**STAFF REPORT
WEST ALLIS PLAN COMMISSION
Wednesday, August 26, 2020
6:00 PM
Virtual Meeting**

9. **Site and Landscaping plan for the proposed reconstruction of the existing Nathan Hale Parking lot on property located at 11601 W. Lincoln Ave. submitted by Steve Eichman, West Allis West Milwaukee School District (Tax Key No. 483-9999-002).**

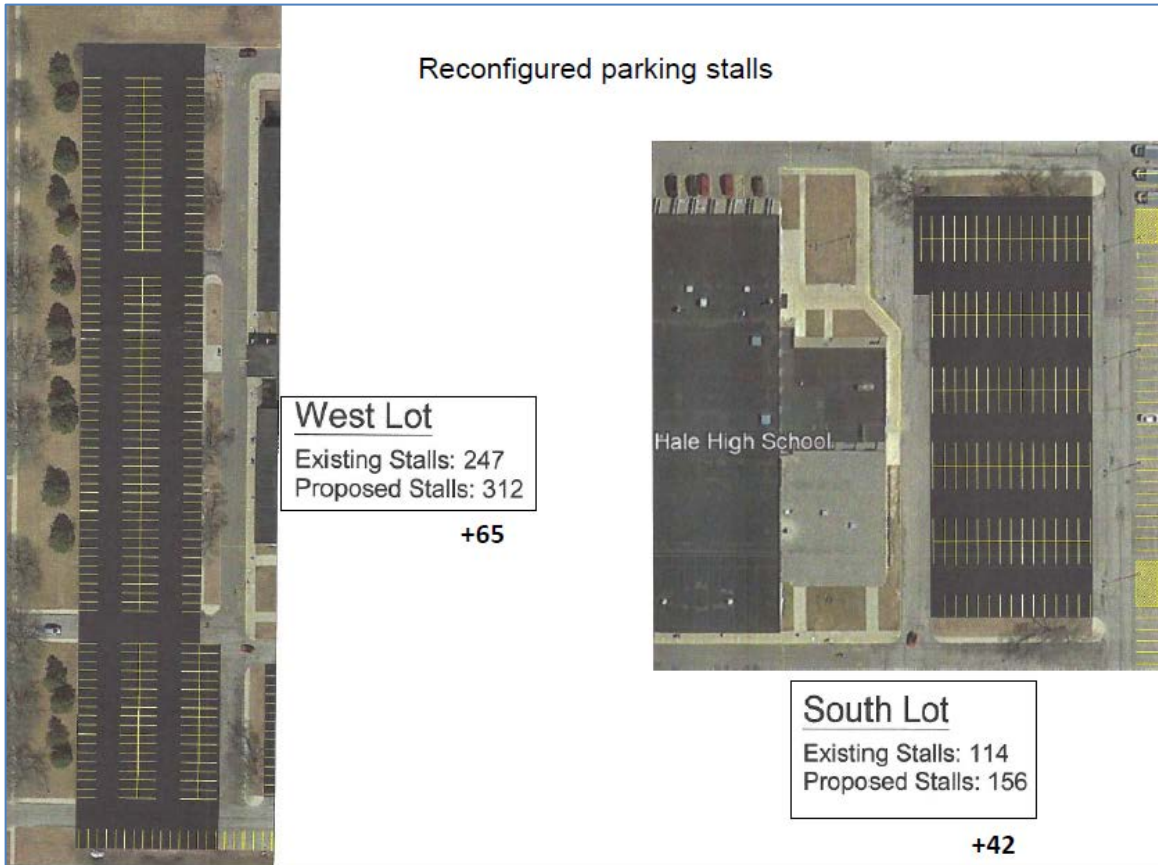
The school district is removing and replacing 195,137-sf of existing paved area and replacing it. As part of the scope of work the angled parking configuration is changing to a 90 degree or perpendicular pattern, new curb and gutter, catch basins and drain tile. The existing landscaping islands along the west side of the building (drop off lane area) and within the south parking lot area will remain.

configuration results in some additional parking stalls without increasing the footprint of the paved area. As part of the reconfiguration, staff has worked with the school district to install some additional landscaping within the parking lot and on the perimeter of the parking lot. Details will be shared at the meeting, but options include landscaping at the end caps of the south end of the west parking lot, or a larger island located within the center/double row of parking. Additionally 3 new evergreen trees along the north end perimeter of the west parking lot (fronts W. Lincoln Ave.).

1. Revised site and landscaping plan being submitted to the Department of Development to show the following: (a) additional 3 evergreens trees along the north end of the west parking lot; (b) add landscaping islands on south endcaps of the reconfigured west lot, or add one large landscaping island on the south end of the west lot; (c) key being provided to delineate species, quantities and sizes; (d) Lighting plans to show parking lot lighting photometric plan, light fixture and pole details, full cut off light fixtures to limit splay beyond property lines. Contact Steve Schaer, Manager of Planning and Zoning with questions (414) 302-8466.
